Aspen 1-New Brighton

Project# P09-038/M09-032

Final Environmental Impact Report (Revised)

JULY 2015

**Figure 4-2
 City of Sacramento Zoning Designations**

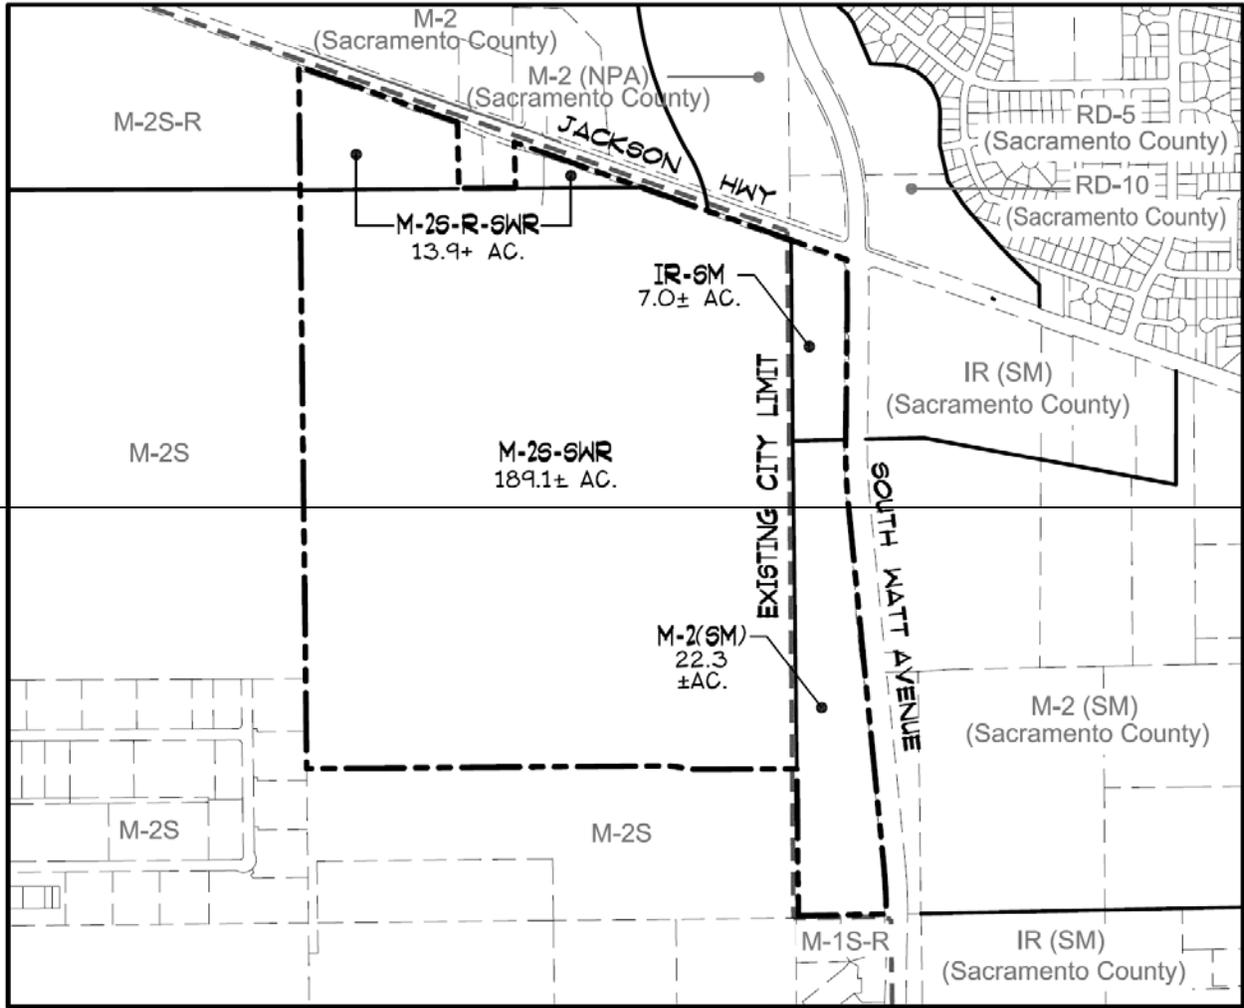
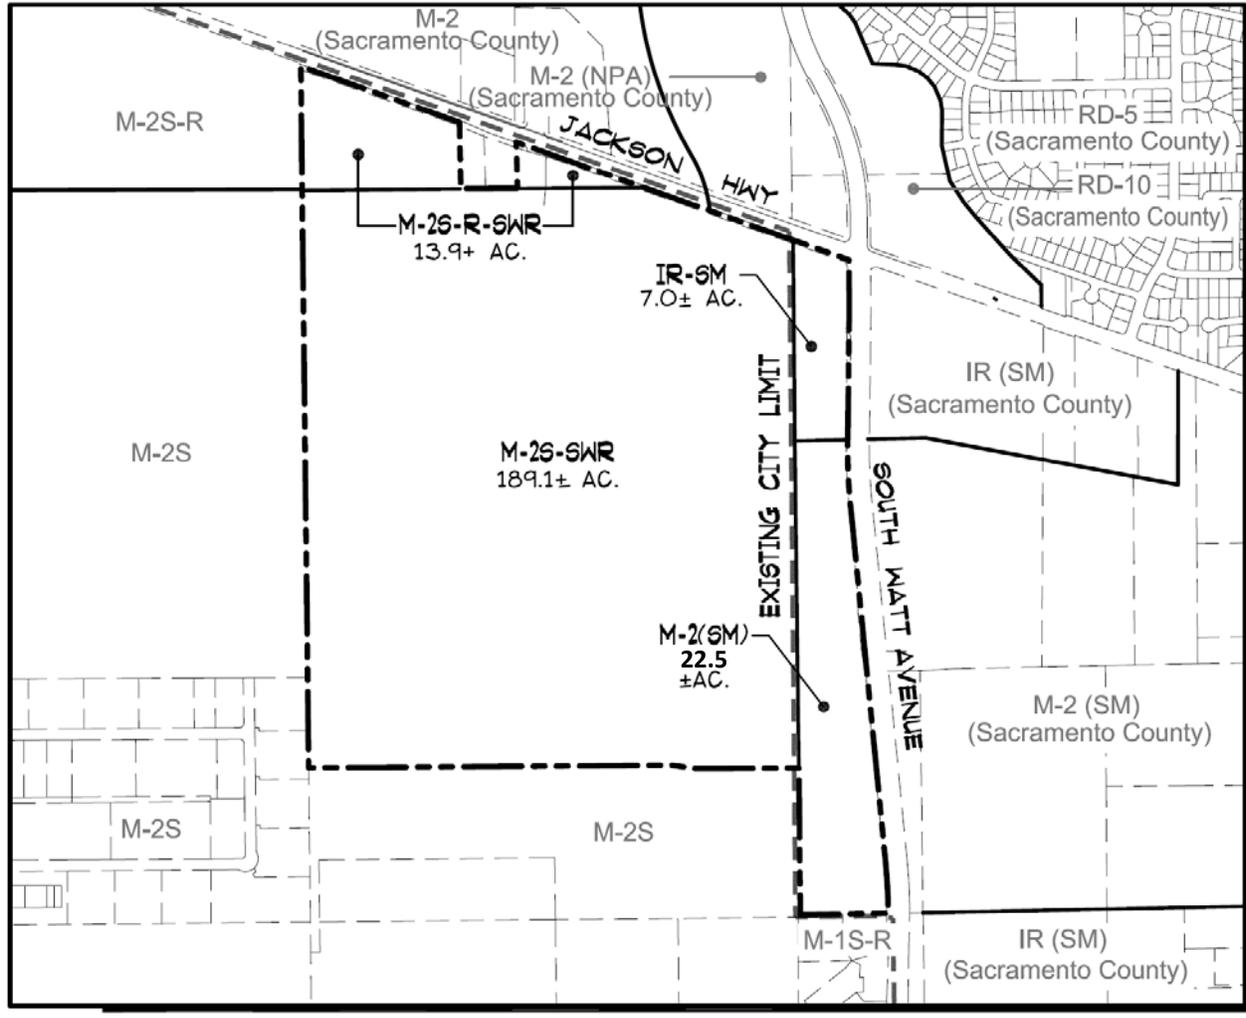
For clarification purposes, Figure 4-2 on page 4-6 in Chapter 4, Land Use, Population, and Housing, of the Draft EIR is hereby revised as shown on the following page. The change is for clarification purposes only and does not alter the conclusions of the Draft EIR.

Figure 4-6
 Rezone Exhibit

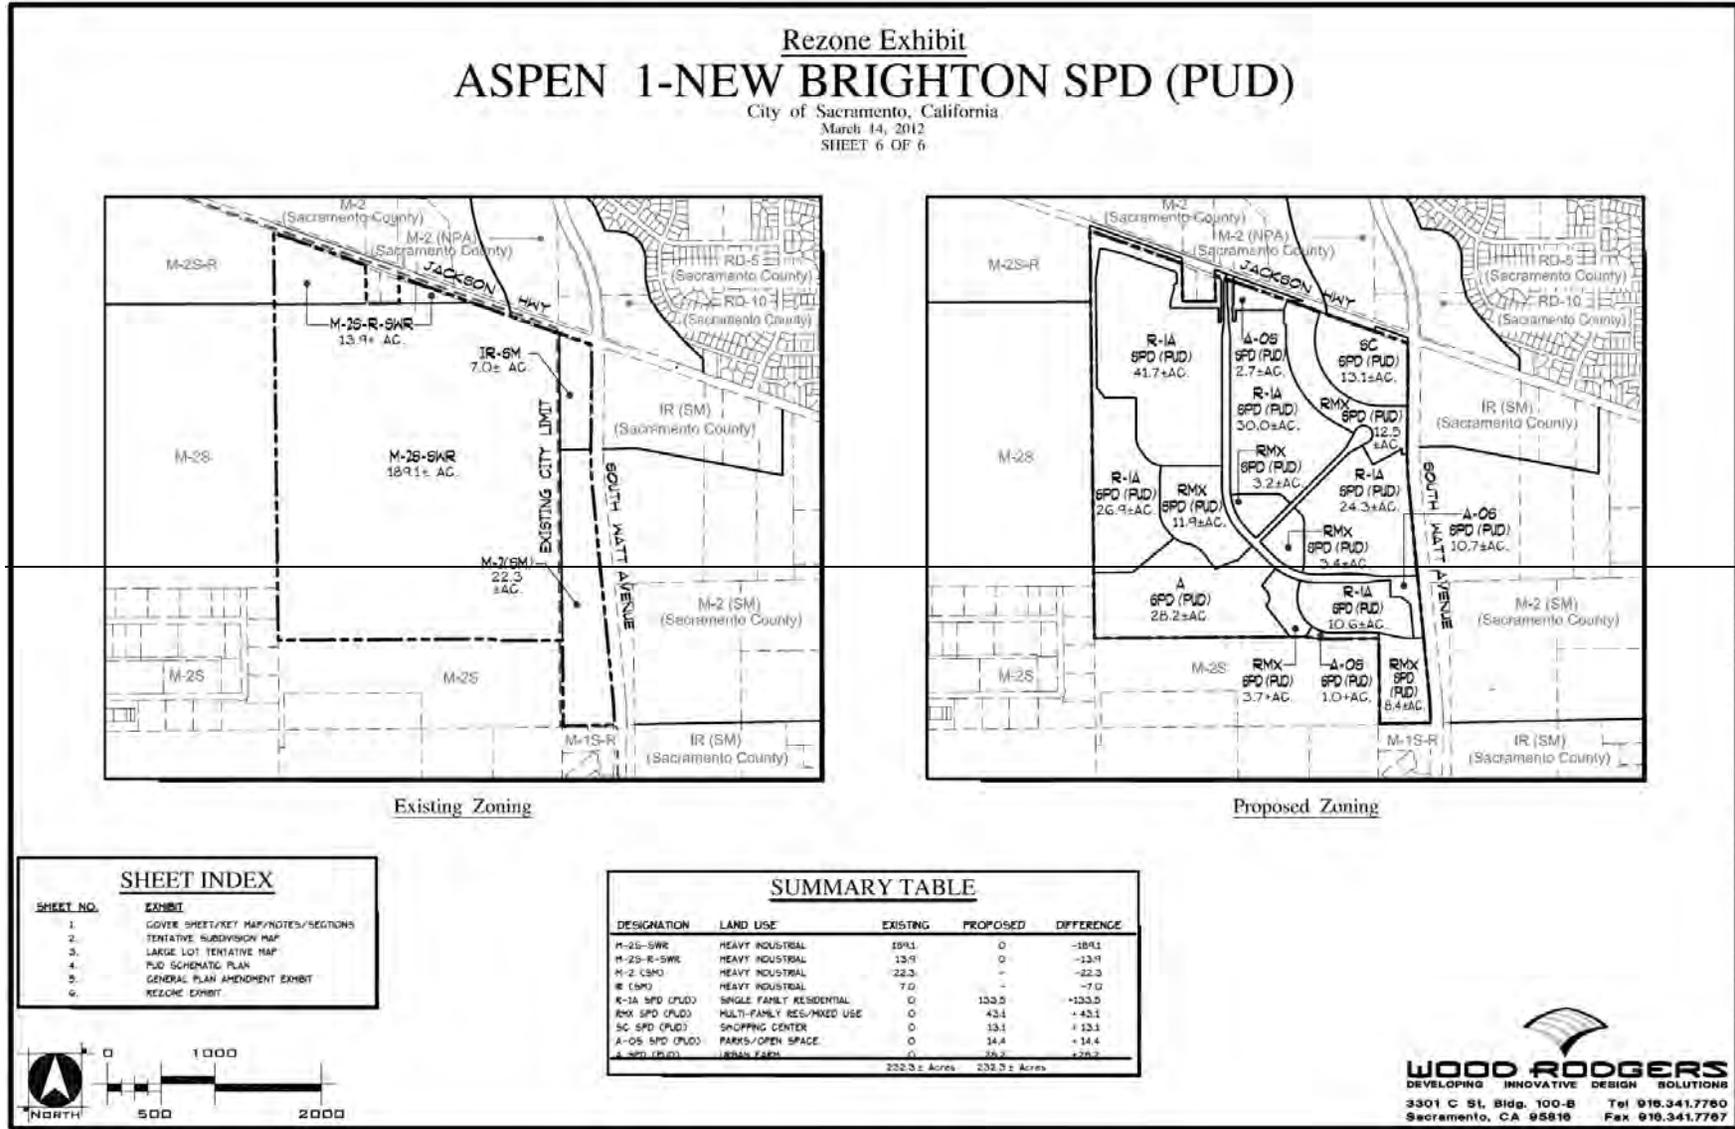
For clarification purposes, Figure 4-6 on page 4-24 in Chapter 4, Land Use, Population, and Housing, of the Draft EIR is hereby revised as shown on the following page. The change is for clarification purposes only and does not alter the conclusions of the Draft EIR.

Figure 5.10-4
Sacramento County Bicycle Master Plan – Existing and Planned Bicycle Facilities

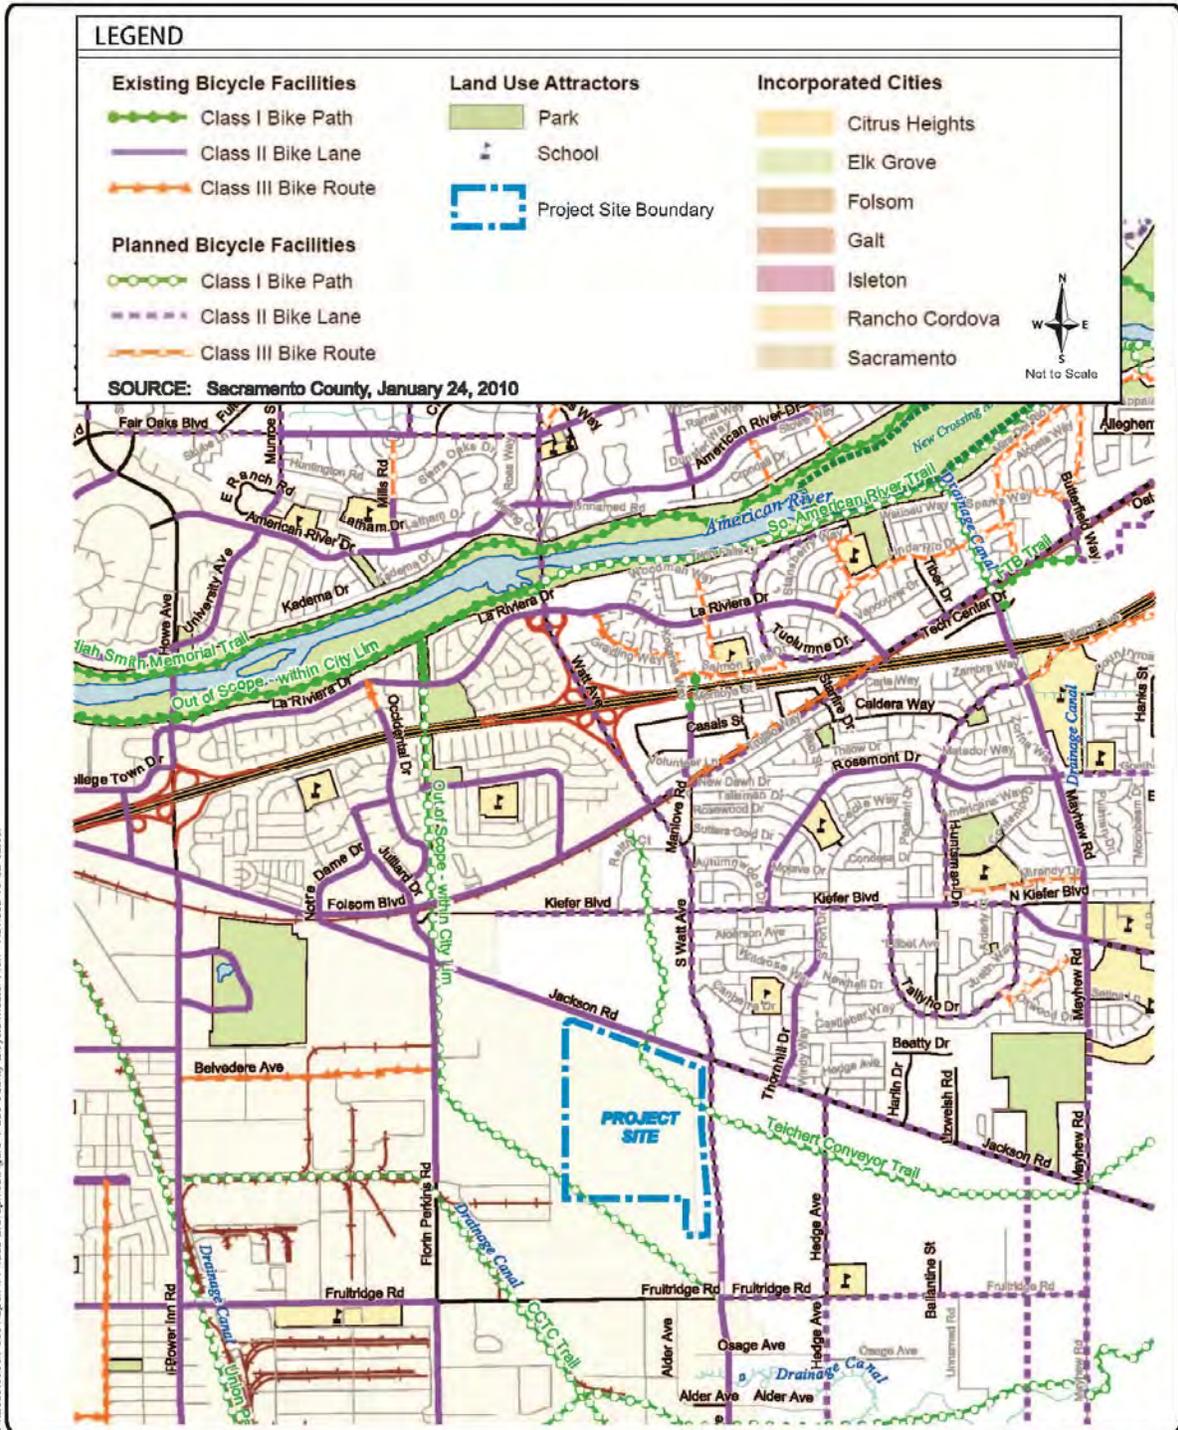
Sacramento County ~~is in the process of updating its~~ adopted an updated Bicycle Master Plan. ~~Adoption of the plan is anticipated in early April 2011.~~¹ Figure 5.10-4 illustrates the ~~draft~~ master plan facilities near the project site.

Figure 5.10-4, on page 5.10-7 of the Draft EIR has been updated to reflect the Sacramento County Bikeway Master Plan, with Amendments through January 24, 2012, and is hereby replaced by the figure on the following page. The change is for clarification purposes only and does not alter any of the conclusions contained within the Draft EIR.

Figure 6-1
Reorganization (Annexation & Detachment) Area

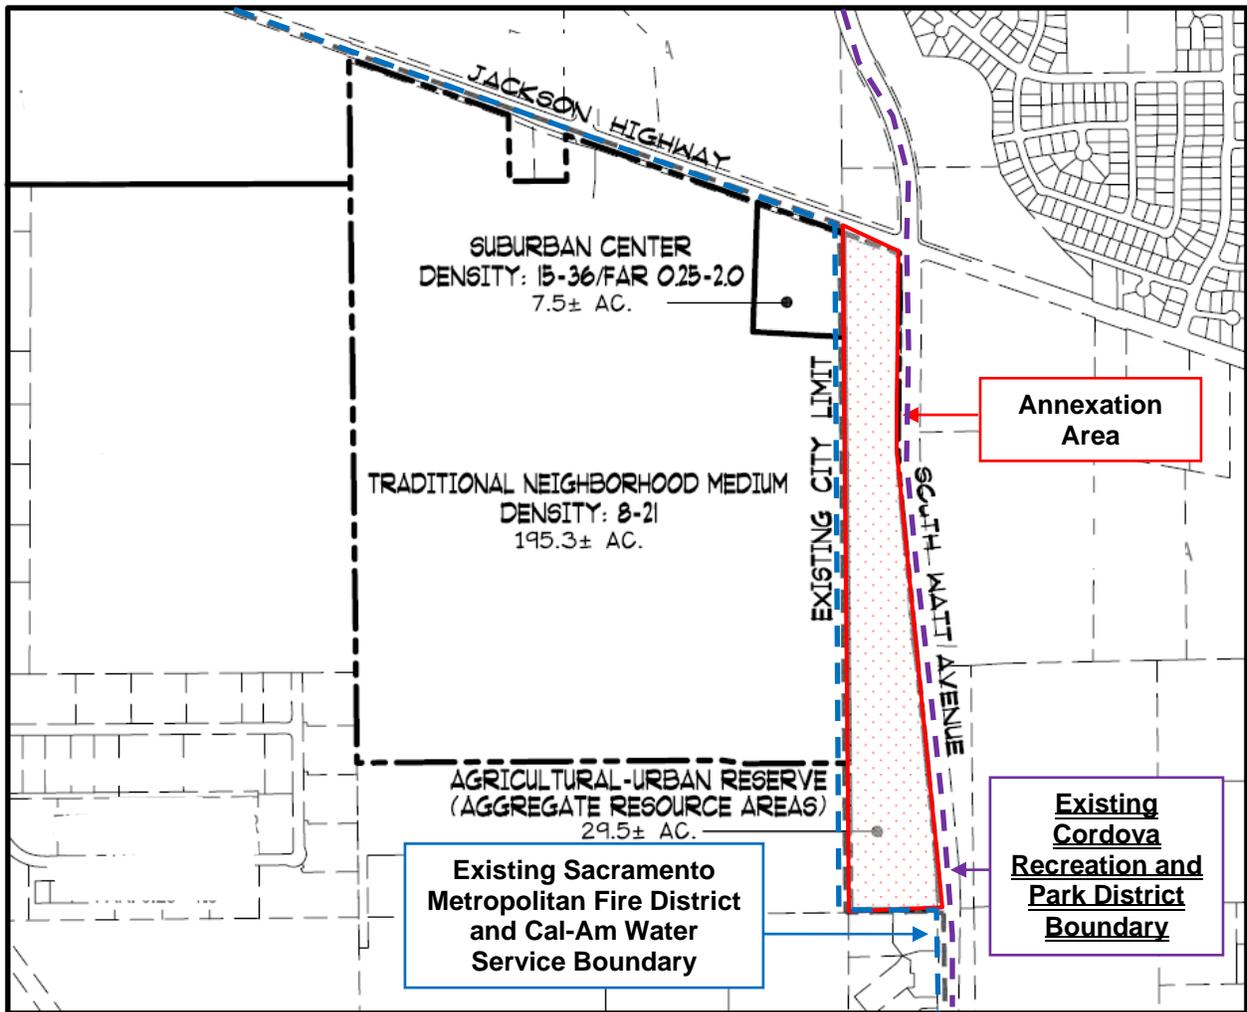
For clarification purposes, the existing Cordova Recreation and Park District boundary is hereby added to Figure 6-1 on page 6-2 in Chapter 6, Reorganization, of the Draft EIR as shown on the following page. The change is for clarification purposes only and does not alter the conclusions of the Draft EIR.

Figure 5.10-4
Sacramento County Bicycle Master Plan – Existing and Planned Bicycle Facilities

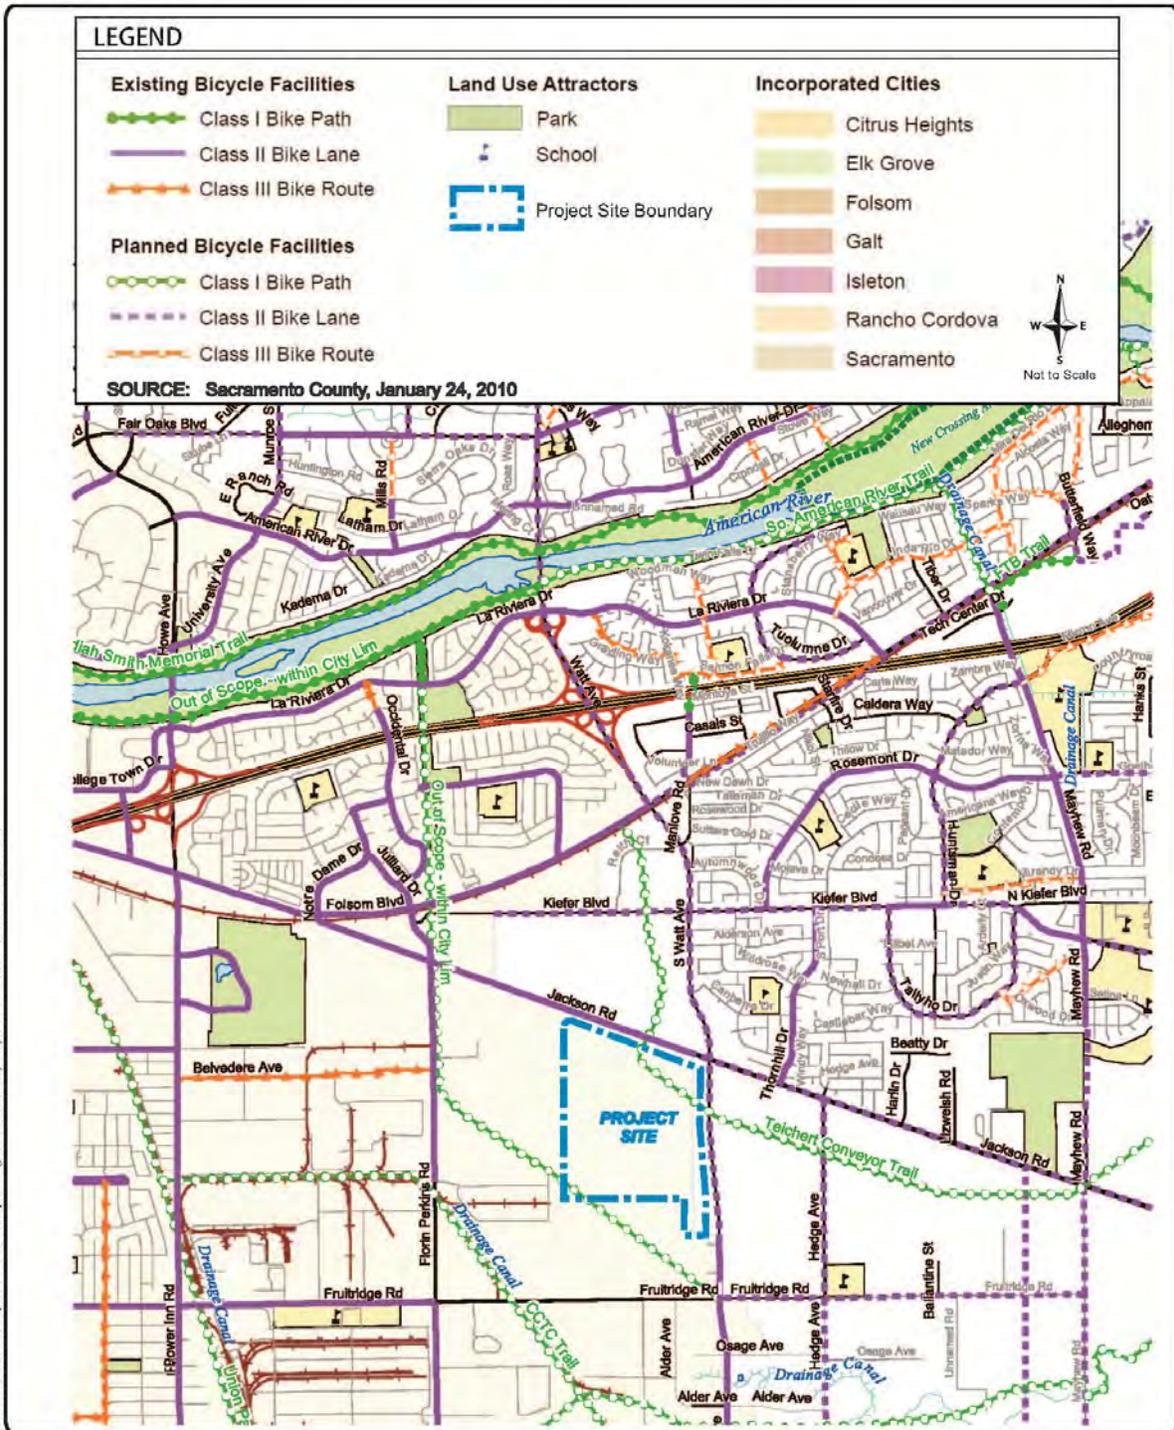
Page 5.10-7, Figure 5.10-4. As discussed above with respect to page 5.10-5 of the DEIR, the Sacramento County Bicycle Master Plan update was completed and adopted in April 2011. Therefore, this figure, which was based on a draft of the proposed Bicycle Master Plan dated January 2010, should if needed to reflect the adopted Bicycle Master Plan.

Sacramento County ~~is in the process of updating its~~ adopted an updated Bicycle Master Plan. ~~Adoption of the plan is anticipated in early April 2011.~~¹ Figure 5.10-4 illustrates the ~~draft~~ master plan facilities near the project site.

In response to the comment, Figure 5.10-4, on page 5.10-7, Chapter 5.10, of the Draft EIR has been updated to reflect the Sacramento County Bikeway Master Plan, with Amendments through January 24, 2012, and is hereby replaced by the figure on the following page. The change is for clarification purposes only and does not alter any of the conclusions contained within the Draft EIR.
